# MONITORING YEAR 7 ANNUAL/CLOSEOUT REPORT

## CANDY CREEK MITIGATION SITE

RE: Draft Monitoring Year 7 Report Comments  
Candy Creek Mitigation Site (DMS #96315)  
Cape Fear River Basin – CU# 03030002 - Guilford County  
Contract # 005794

## Monthly Rainfall Data

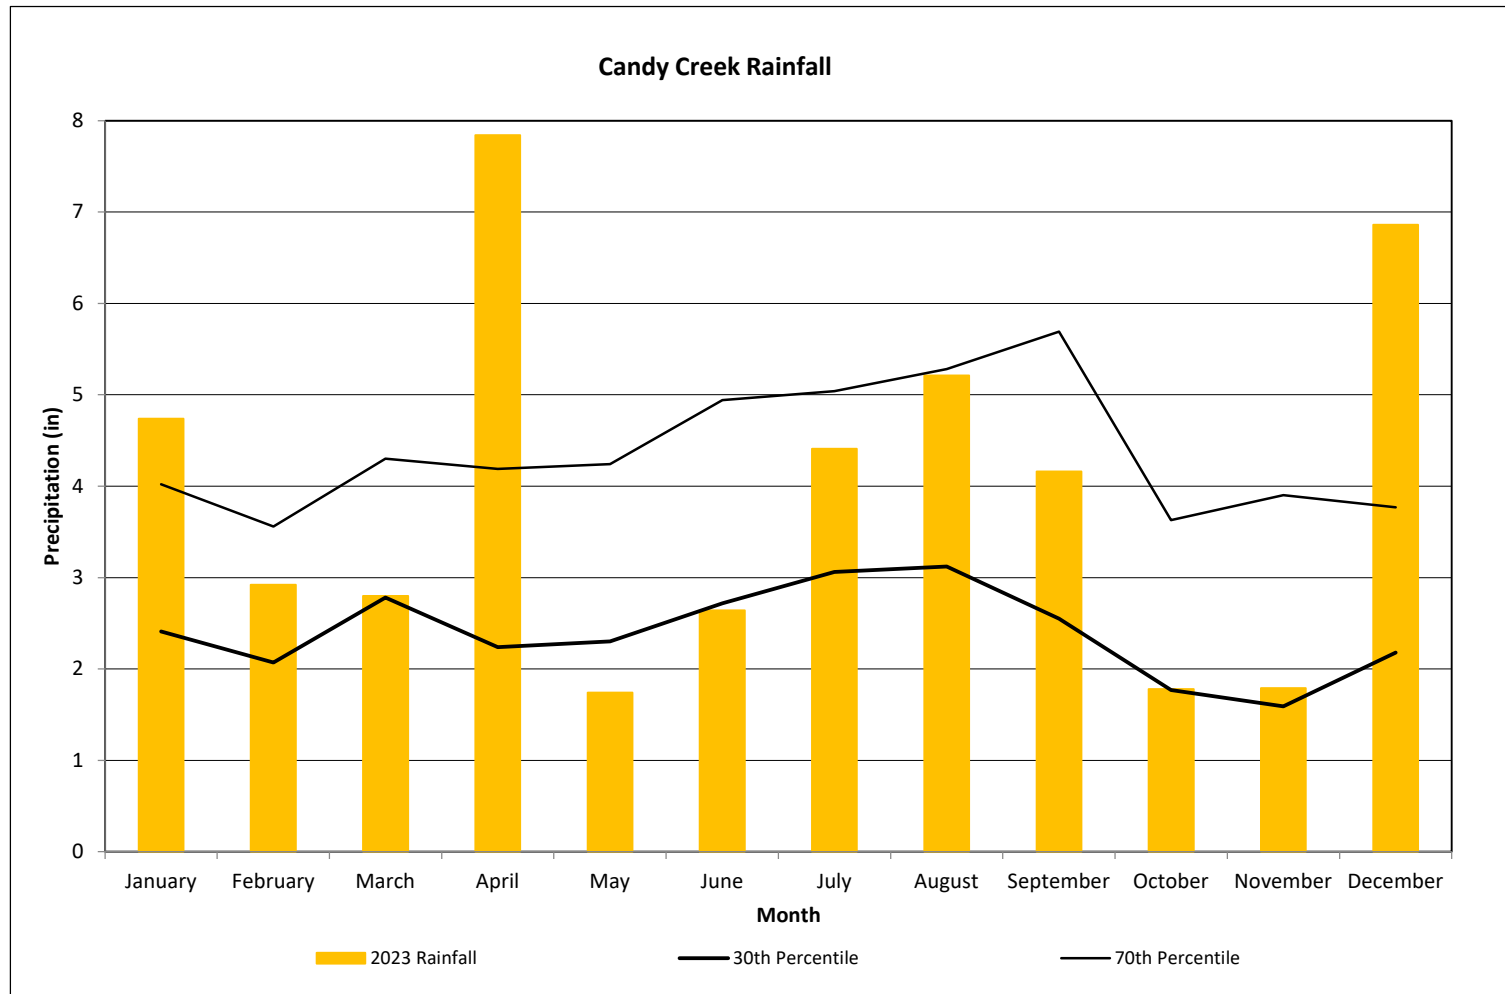
**DMS comment: Appendix 5: Please include monthly rainfall data (compared to 30th and 70th percentiles – site data sources for percentiles) for the region/county for the entire calendar year.**

*Wildlands' response: The rainfall data from 2023 is summarized in Table 15 and is shown in the Monthly Rainfall Data plot. Both were added to Appendix 5.*
